**CITY OF WARWICK, RHODE ISLAND
WARWICK SEWER AUTHORITY
BAYSIDE SEWER SYSTEM PRESSURE SEWER
CONTRACT 86B
ADDENDUM NO. 2**

January 8, 2020

The following information is provided as part of the Contract Documents as Addendum No. 2.

CUT & MATCH DETAIL, LOCAL STREETS
NOT TO SCALE

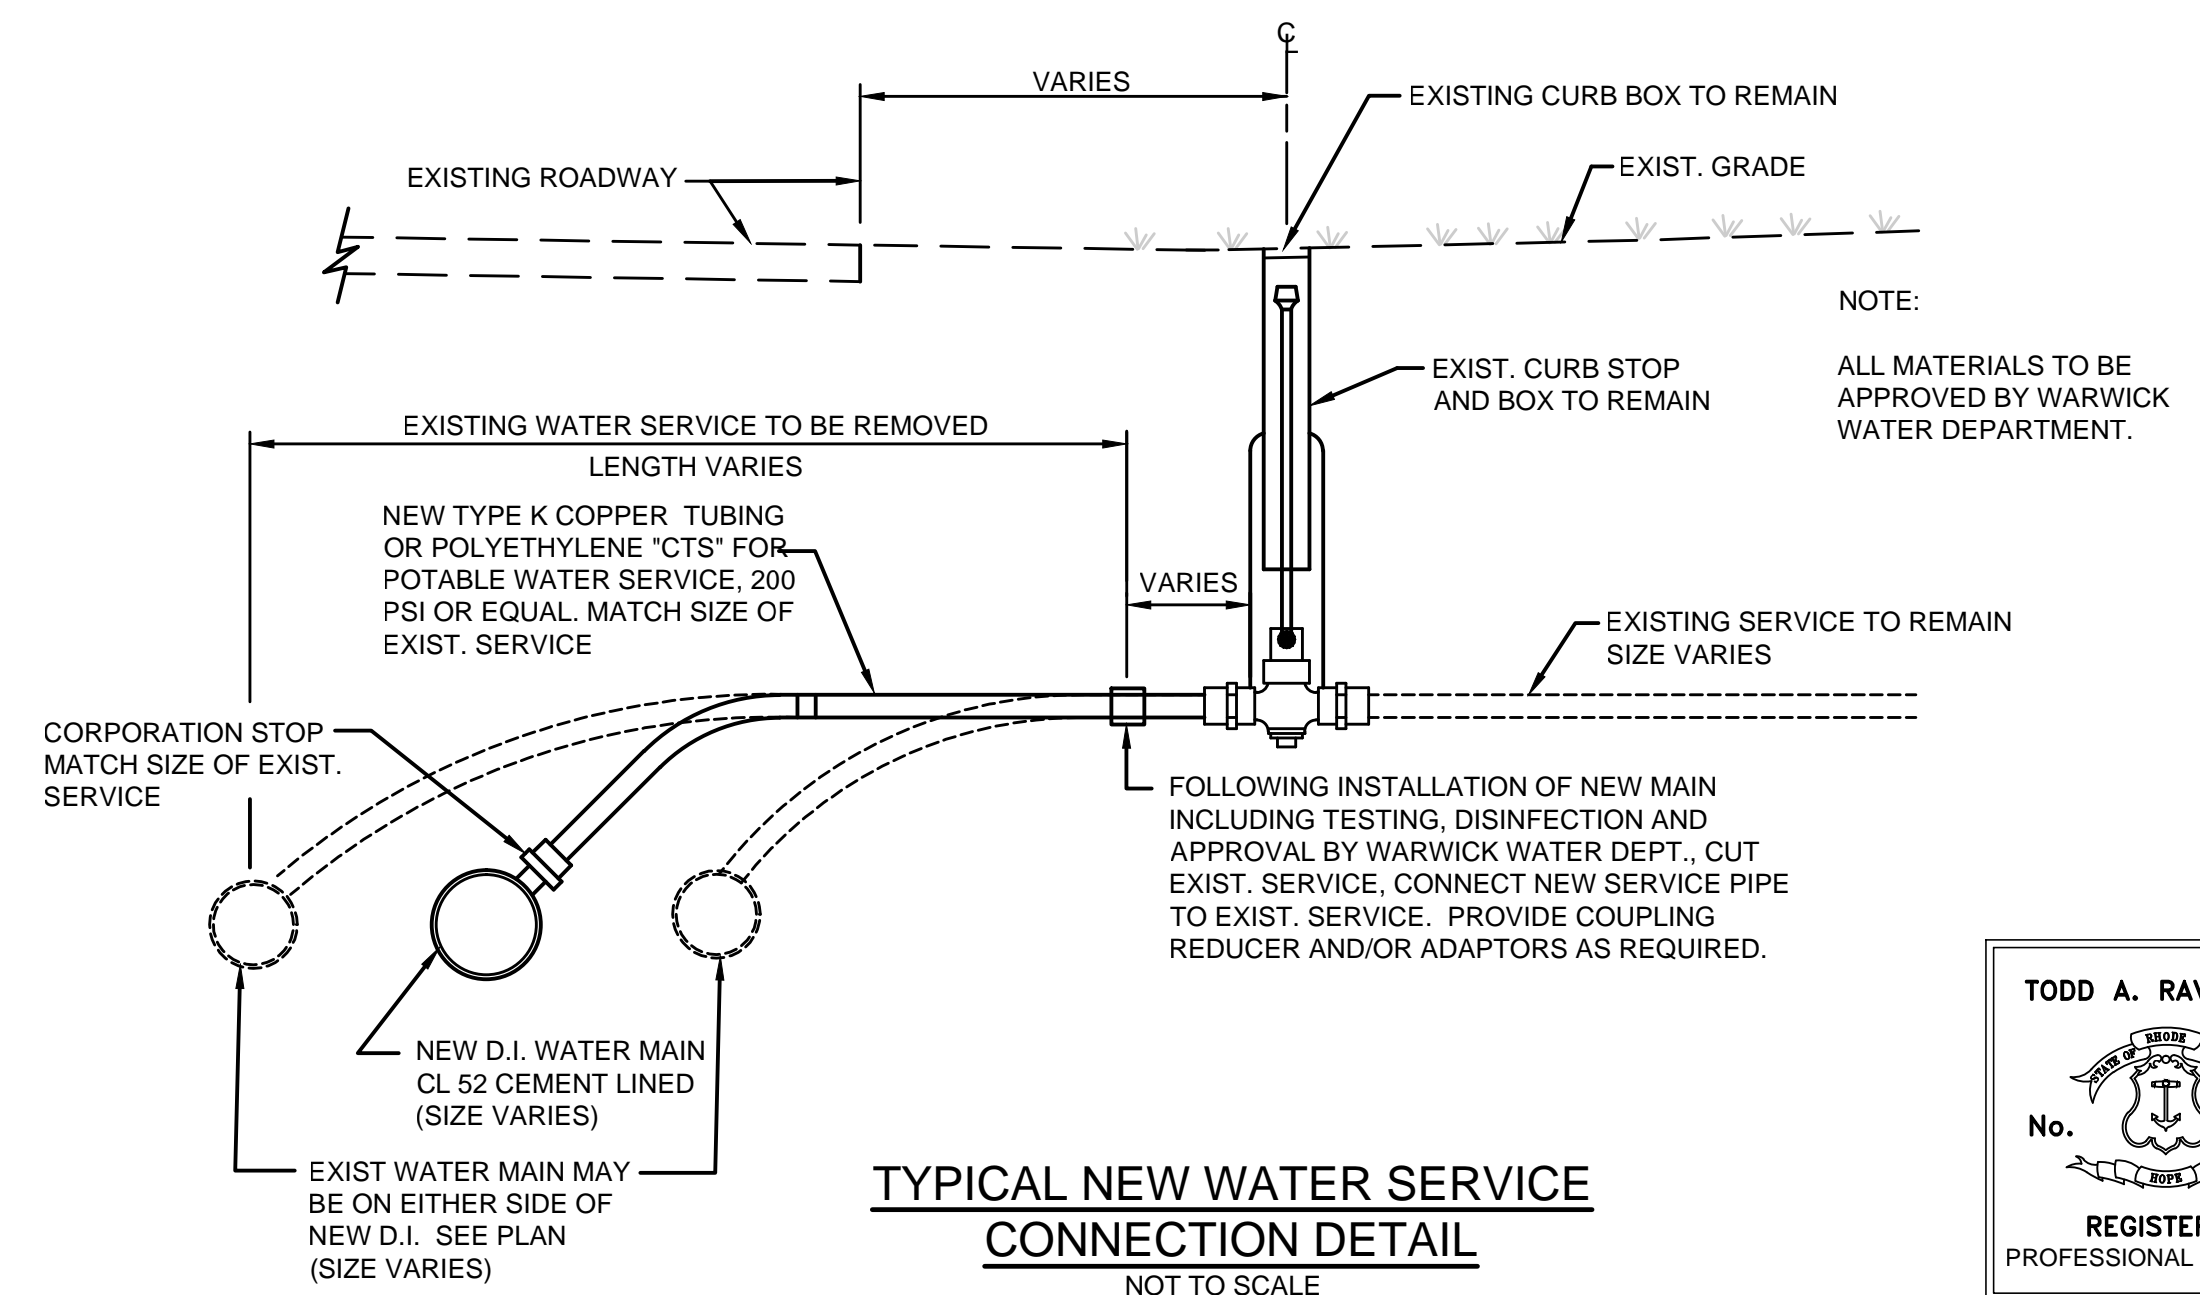
1. Plan Sheet No. 58 Details – 1, Open Excavation, Delete and Replace with the attached Plan.
2. Plan Sheet No. 60 Details – 3, Pavement and Water, Delete and Replace with the attached Plan
3. Plan Sheet No. 62 Details – 5, Open Trench Excavation, Delete and Replace with the attached Plan.
